1. PEDESTRIANS

2. VEHICULAR TRAFFIC

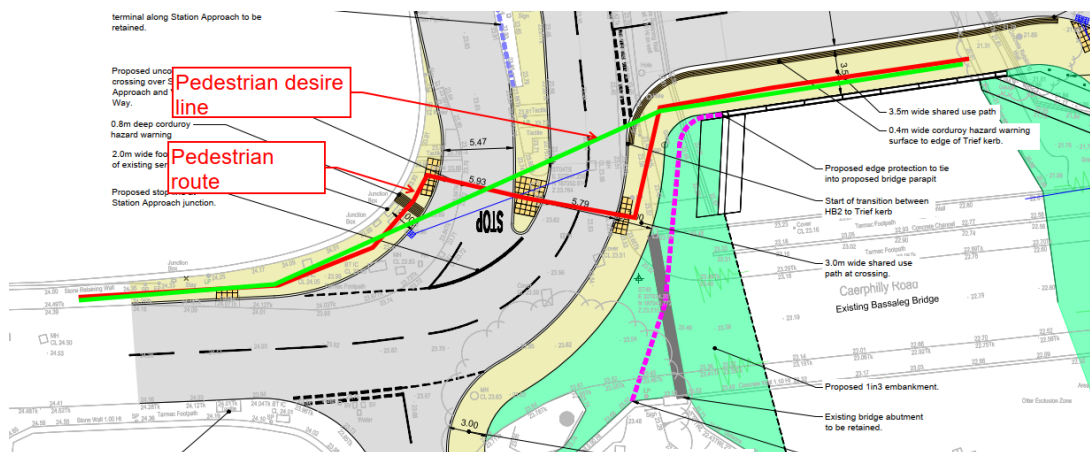
The radius and width of the entry into Station Approach have been altered which has potential to encourage higher entry speeds. As a result, there is a loss of footway width and the crossing points (for pedestrian movement between Caerphilly and Viaduct or Forge Mews) have been relocated. The submitted pedestrian visibility splays show that intervisibility between pedestrians and drivers is reduced dramatically (to 12.9 leading and 8.6 secondary direction). This is not considered adequate for the likely speeds. This raises an objection on safety grounds.

The scheme is located within a 20mph area which restricts speeds vehicles will be travelling at.

The approach to Station Approach and the pedestrian crossing of Viaduct Way has been realigned to provide a single crossing alignment over Station Approach and Viaduct Way for the shortest distance possible. This removed the excessively wide (approx. 15m) crossing of Viaduct Way. The position of the crossing has moved south to ensure the eastern end of the crossing is outside the length of trief kerbs, whilst providing a crossing as closely aligned to the pedestrian desire line as possible, see image below.

In order to provide a crossing at this location, the kerblines at the western end of the crossing on Station Approach is required to be moved west so that sufficient width remains available for the vehicle entrance to Station Approach. The narrowing also allows the central island to be curved, clarifying to drivers that Caerphilly Road to Viaduct Way is the main through route.

To increase the visibility to 25m, the cemetery wall would need to be removed and/ or the Shared Use Path on the eastern side removed or reduced in width. Both options were not considered feasible as a result of heritage constraints and maintaining pedestrian connectivity from Churchmead. Removal of the crossing from this location would risk pedestrians not following a longer route to the south and encourages unsafe crossing behaviour.

Providing the full 25m visibility for the crossing of Viaduct Way has been prioritised as the majority of vehicles will take this route, as opposed from Station Approach, which is a private road which provides access solely for a restaurant, church hall and 5 residential properties. It is not a through road.
